APPLICATION NO.	FILING DATE	FIRST NAMED INVENTOR	ATTORNEY DOCKET NO.	CONFIRMATION NO.
10/776,203	02/12/2004	Rajiv Yadav Ranjan	50103-553	2760
	7590 06/06/200 ', WILL & EMERY	EXAMINER		
600 13th Street, N.W.			MCDONALD, RODNEY GLENN	
Washington, DC 20005-3096			ART UNIT	PAPER NUMBER
			1795	
			MAIL DATE	DELIVERY MODE
			06/06/2008	PAPER

Application No.	Applicant(s)
	10/776,203	RANJAN ET AL.
Office Action Summary	Examiner	Art Unit
	Rodney G. McDonald	1795
The MAILING DATE of this communication ap Period for Reply	pears on the cover sheet with the c	orrespondence address
A SHORTENED STATUTORY PERIOD FOR REPL WHICHEVER IS LONGER, FROM THE MAILING ID. - Extensions of time may be available under the provisions of 37 CFR 1 after SIX (6) MONTHS from the mailing date of this communication. - If NO period for reply is specified above, the maximum statutory of Failure to reply within the set or extended period for reply will, by stature Any reply received by the Office later than three months after the mailing earned patent term adjustment. See 37 CFR 1.704(b).	DATE OF THIS COMMUNICATION .136(a). In no event, however, may a reply be tind d will apply and will expire SIX (6) MONTHS from te,

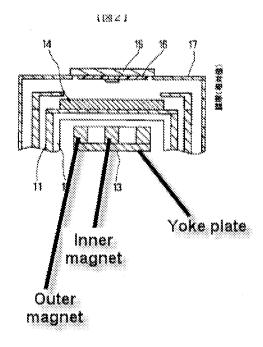
Akiyama teach in Fig. 2 an annular shaped magnetron assembly. From Figure 2 it appears that there is an outer ring shaped magnet and an inner magnet on a disk yoke. See annotated Figure 2 below.

In response to the argument that Akiyama et al. does not teach an annular shaped magnet, it is argued Akiyama teach in Fig. 2 an annular shaped magnetron assembly. From Figure 2 it appears that there is an outer ring shaped magnet and an inner magnet on a disk yoke. See annotated Figure 2 below.
